LEE'S SUMMIT
MISSOURI
Development Services Department

Development Services Staff Report

File Number	PL2025-207
File Name	PRELIMINARY DEVELOPMENT PLAN – East Village Phase 1
Applicant	East Village Investors, LLC
Property Address	Approximately 130 gross acres generally located at the southeast corner of the intersection of US 50 Hwy and South M-291 Hwy
Planning Commission Date Heard by	November 13, 2025 Planning Commission and City Council
Analyst	Hector Soto, Jr., AICP, Senior Planner

Figure 3 - Proposed monument sign locations.

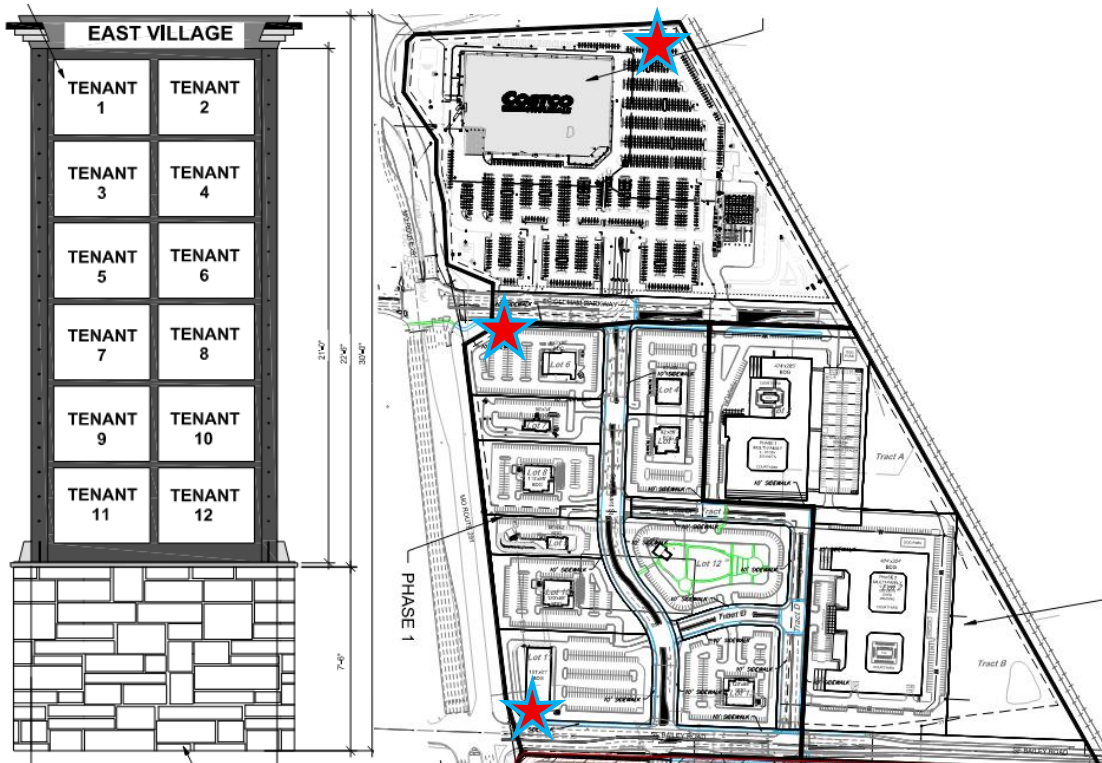
The proposed development will be generally subject to the PMIX sign standards, except that the applicant seeks approval for three (3) oversized monument signs to serve as the shopping center’s primary identification signage at the two entry points along South M-291 Hwy and at the northeast corner of the site facing US 50 Hwy. The applicant also seeks approval to allow a total of six (6) wall signs on the Costco building versus the standard three (3) walls signs for a single-tenant building. Save for the aforementioned signage requests, individual tenants shall otherwise comply with the PMIX sign standards but may submit for individualized sign package approvals under separate application as allowed by the UDO once individual tenants determine their respective signage needs.

The applicant proposes an allowance for oversized monument signs, as described above, along its two highway frontages to provide a primary means of identification and wayfinding for the development near the intersection of two highways. The City Council relatively recently approved two (2) identical oversized signs for the Oldham Village development on the west side of South M-291 Hwy for the intersection of the South M-291 Hwy and SW Oldham Pkwy, and for the northwest boundary of the development facing US 50 Hwy. The City Council has also relatively recently approved two (2) oversized monument signs for a similar commercial development (Summit Orchards North) having a height of 45’ and an overall sign structure size of 637.5 sq. ft. along the project site’s I-470 highway frontage. Staff supports the applicant’s proposal for taller and larger monument signs along the highway frontages as depicted below.

9. Approval shall be granted for three (3) oversized, primary identification monument signs in Phase 1 with an overall height of 30', 224 sq. ft. sign face area and 312 sq. ft. overall sign structure area to be located at the northeast project site boundary, the southeast corner of South M-291 Hwy/SE Oldham Pkwy, and the northeast corner of South M-291 Hwy/SE Bailey Rd as depicted on the preliminary development plan October 30, 2025, and monument sign detail dated August 7, 2025.

Figure 4 - Elevation showing wall signage (east and partial southeast façade)

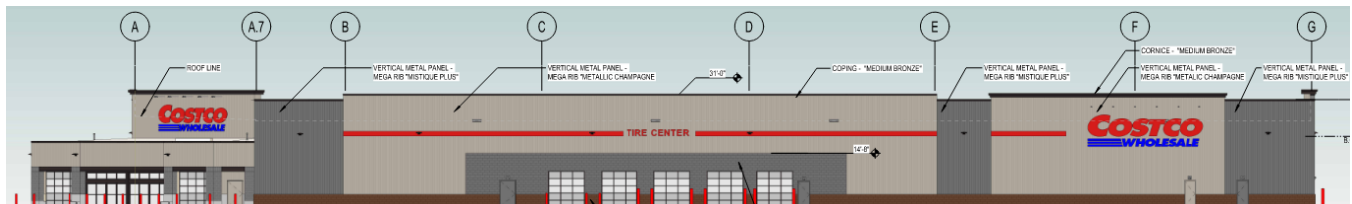
The table below outlines the characteristics of the proposed wall signs for Costco on Lot 1.

10. Approval shall be granted to allow six (6) wall signs on the Costco (Lot 1) building as depicted on the building elevations dated August 8, 2025. All other lots in Phase 1 (Lots 2-13) shall be subject to the governing sign standards and allowances of the PMIX zoning district.

Figure 11 - Node 7 clouded in red

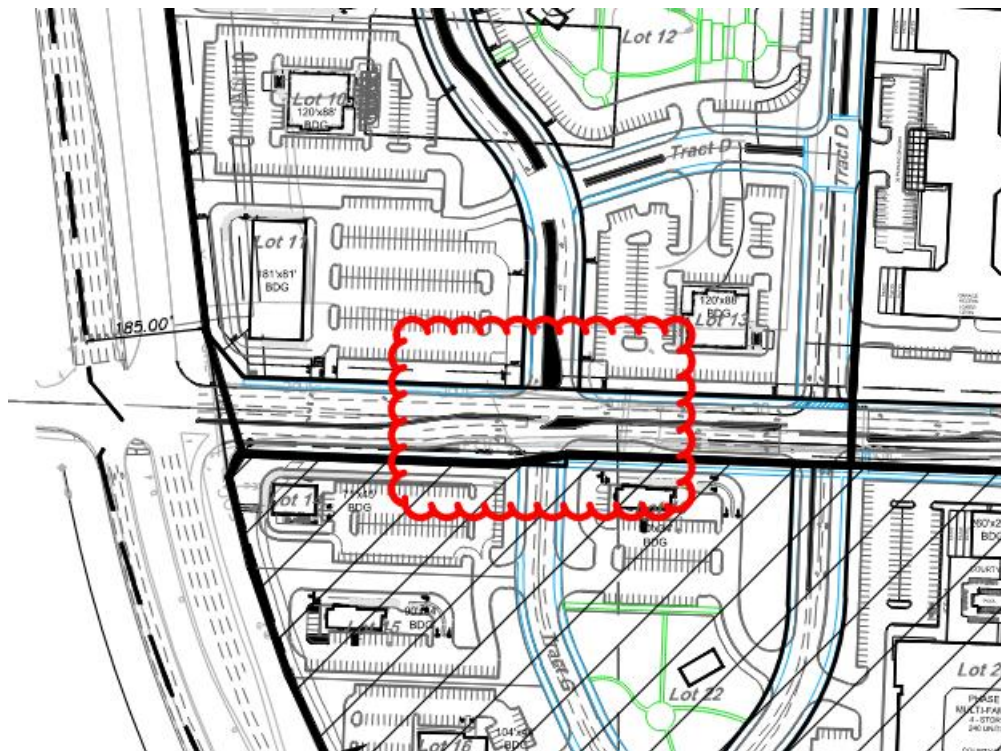
Staff supports the recommended road improvements in the TIS, but has concerns over a proposed Right-in/Right-out/Left-in access point along SE Bailey Road at the intersection with the proposed north-south collector street (identified as Node 7 in the TIS). Striking a balance between the applicant's desire to proceed with Left-in capabilities at Node 7 against staff's concern with intersection functionality and safety, condition #4 in the TIA prepared by staff is crafted to offer the applicant two options for Node 7 as it relates to a Left-in. If the Left-in is constructed, the developer shall be required to escrow \$100,000 for a period of at least 10 years for the future reconstruction of the median to limit the intersection to Right-in/Right-out only, with the decision to limit access and drawn upon the escrow for median reconstruction to exclusively reside with the City Traffic Engineer. Alternatively, if no Left-in is constructed, the applicant is only required to submit updated plans reflecting the elimination of the Left-in at the time of permit review. The applicant has been apprised of condition #4 in the TIA and is amenable to it as a condition of approval to the subject preliminary development plan.

Staff recommends approval of the proposed preliminary development plan subject to the conditions noted in the TIA. Any recommended public improvements in the TIA shall be substantially completed prior to issuance of any occupancy permit associated with the phase of development described therein.

Figure 12 - Trash and recycling receptacle area with evergreen landscape screening.

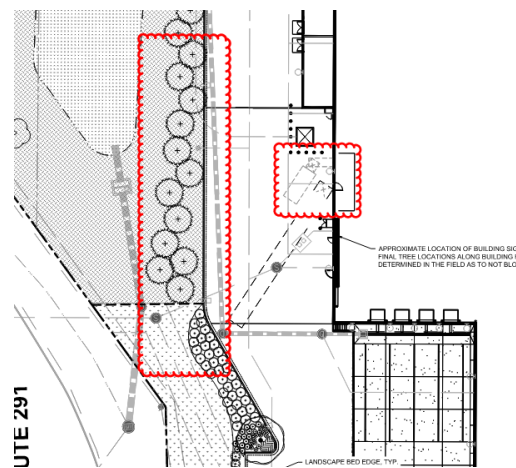
Trash Enclosure Screening (UDO Section 8.110.C). Staff has reviewed the request and supports the requested modification.

- Required – Trash and recycling receptacles shall be opaquely screened on all sides by the use of a permanent enclosure constructed of masonry walls with gates and/or doors for access.

- Proposed – The trash and recycling receptacles located along the west side of the Costco building in the general vicinity of the dock area are proposed with no enclosure. In lieu of an enclosure to house the receptacles, a double-staggered row of evergreen trees and the use of evergreen shrubs along the west parking lot/drive aisle boundary parallel to the receptacles will be installed to screen the view of the receptacles from the South M-291 Hwy frontage.

- Recommended – The applicant's preferred practice for the Costco site is to provide additional evergreen landscape screening of dock areas and trash and recycling receptacle areas rather than constructing structural screens such as masonry walls in areas with high frequency of turning and backing movements by large vehicles (i.e., semis and trash trucks). Staff recommends approval of the modification request.

4. A modification shall be granted to the trash and recycling receptacle screening requirement by a masonry enclosure, to allow screening via the planting of evergreen landscape screening as shown on the landscape plans included in the preliminary development plan in lieu of masonry enclosure screening.
